AAFC Admiral Dam & Downie Lake Dam
Contract No. 5
Low Level Gate System Replacement
CONTRACT #4547-928-714-0-C5

Addendum No. 2

Questions & Answers

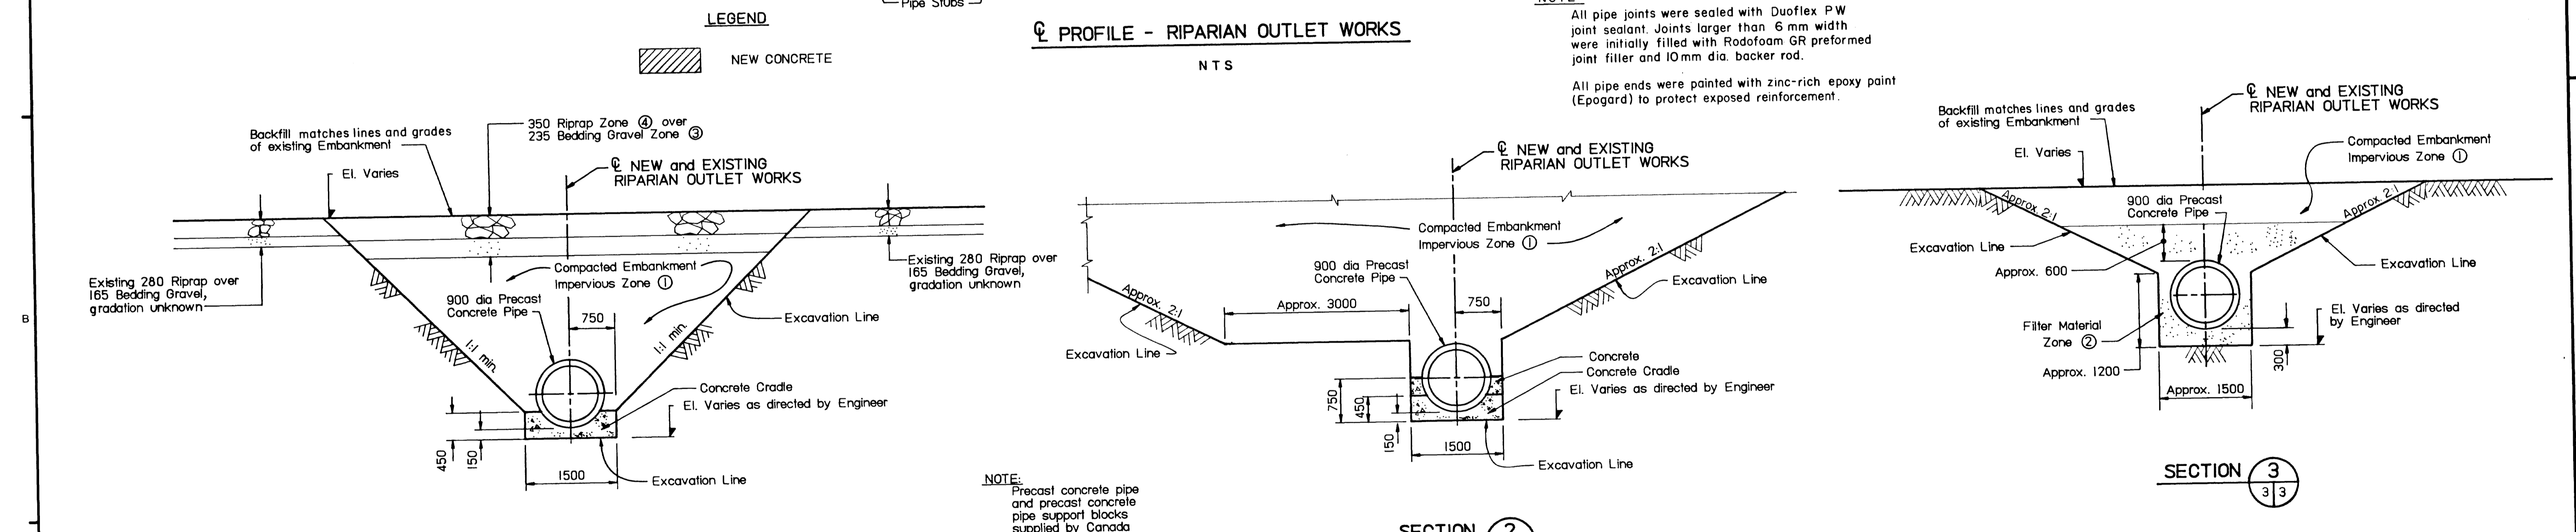
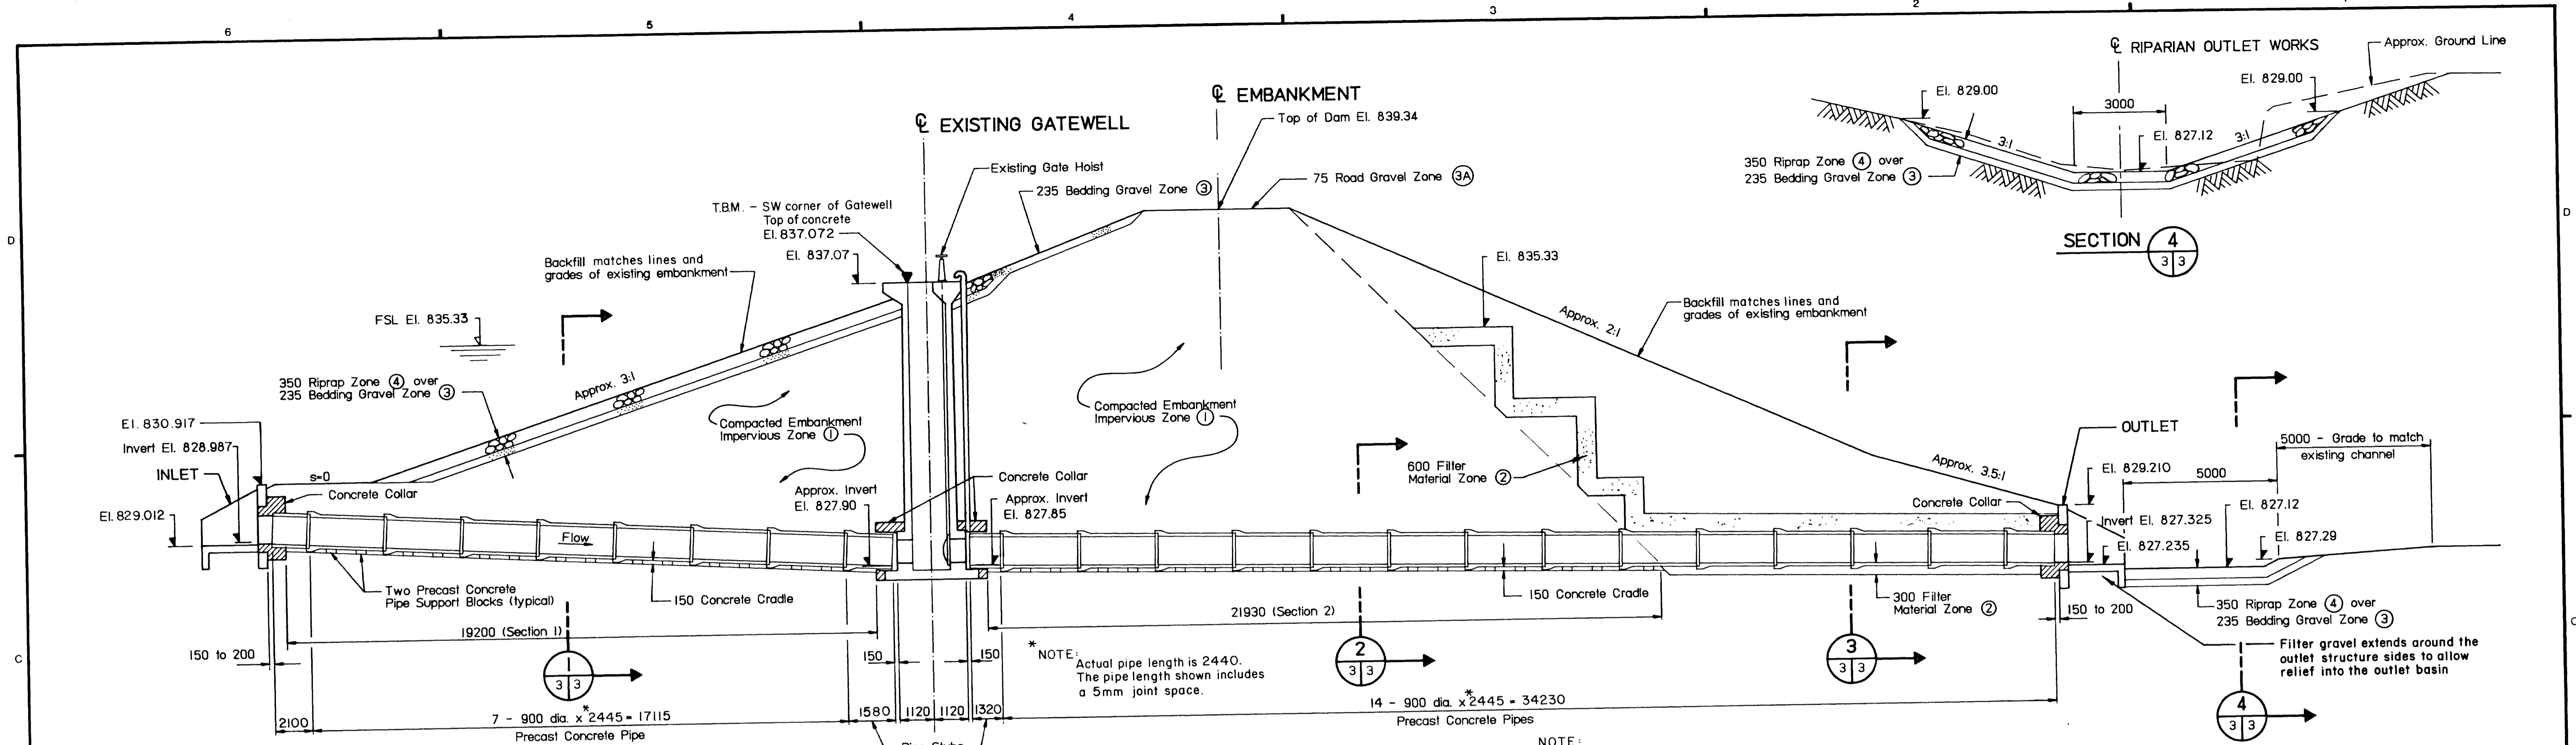
Q2 Is there any detail on the entrance so that a design of a bulkhead could be considered?

A2 See attached drawings.
